Access Compliance Report Public Rights-of-Way (Curb Ramps)

Intersection ID: 26420 Main Street: BEVINGTON_PL Cross Street: CARSWELL_LN Location: NW

ADA ID: 740220608BB6 Ramp Type: PerpDiag Initial Pass/Fail: Fail Overall Compliance: No Severity Score: 1.25

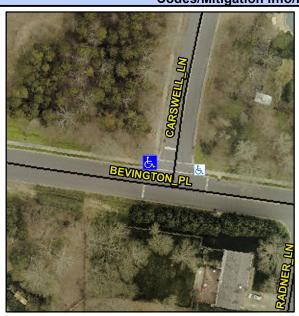
Not Found, R304.5.3

Field Measurements/Component Compliance					
Compliance Description		Data	Comp	oliance Description	Data
N/A	Ramp Length (in)	72.0	Yes	Ramp Slope (%)	6.6
Yes	Ramp Width (in)	48.0	No	Ramp XSlope (%)	3.3
N/A	Flare Type LT	N/A	N/A	Flare Type RT	N/A
N/A	Flare Slope LT (%)	N/A	N/A	Flare Slope RT (%)	N/A
N/A	Flare Traversable LT?	N/A	N/A	Flare Traversable RT?	N/A
N/A	Landing Length (in)	N/A	N/A	DWS Provided?	N/A
N/A	Landing Width (in)	N/A	N/A	DWS Contrast?	N/A
N/A	Landing Slope (%)	N/A	N/A	DWS Length (in)	N/A
N/A	Landing X Slope (%)	N/A	N/A	DWS Full Width?	N/A
N/A	Landing Curb? (Y/N)	N/A	N/A	DWS Offset (in)	N/A
N/A	Shared Landing?	N/A			
N/A	Gutter Ponding?	N/A	N/A	Gutter Slope (%)	N/A
N/A	Gutter Lip Ht (in)	N/A	N/A	Gutter X Slope (%)	N/A
N/A	Painted X Walk1?	No	N/A	Painted X Walk2?	Yes
	X Walk 1 Direction	To S		X Walk 2 Direction	To SE
N/A	X Walk 1 Width (in)	N/A	N/A	X Walk 2 Width (in)	111.0
	X Walk 1 Slope (%)	0.7		X Walk 2 Slope (%)	4.2

Remove & Replace Curb Ramp With Two New Directional Ramps or Equivalent.
